ADA Curb Ramp New Construction Inspection Form (Perpendicular)

WASHINGTON COUNTY OREGON

North-South Road Name	Project No.	Sheet No.	Intersection No.	East-West Road Name
Nw 289th	24952.54			Nw union

Corner Position: 1

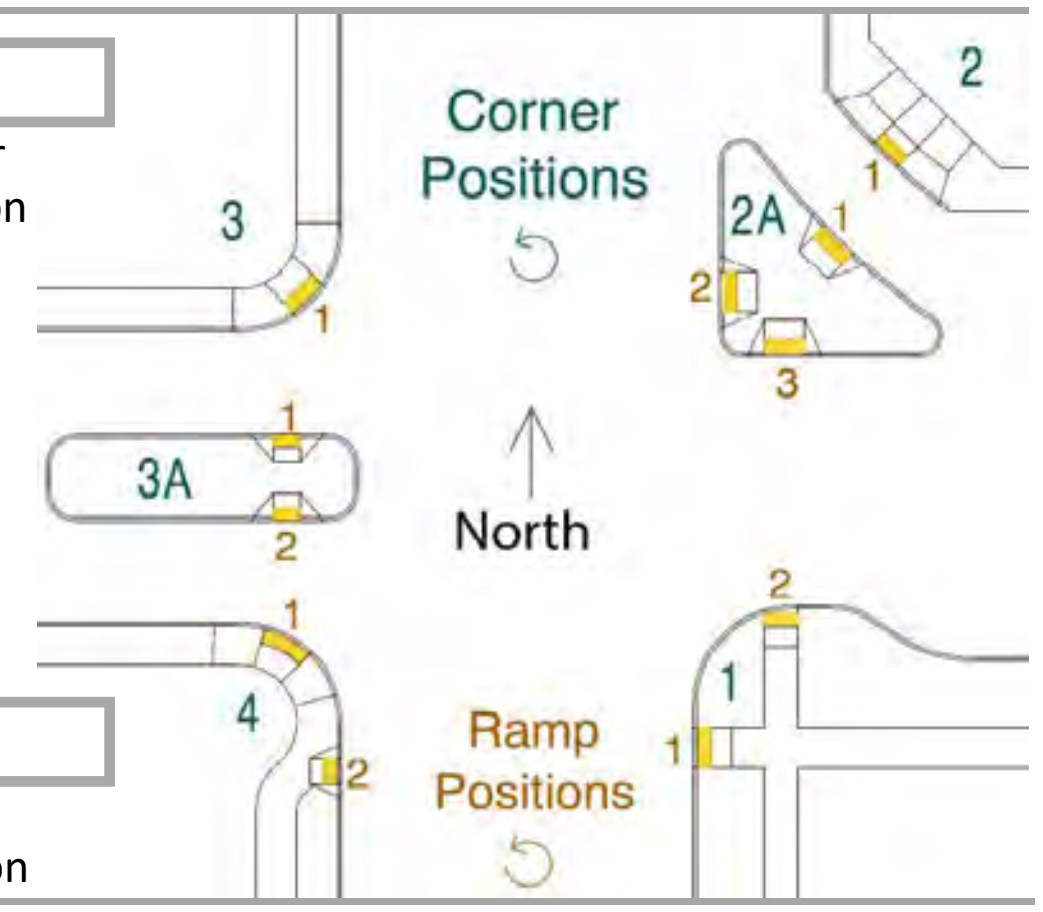
IITD, RR 1 fail
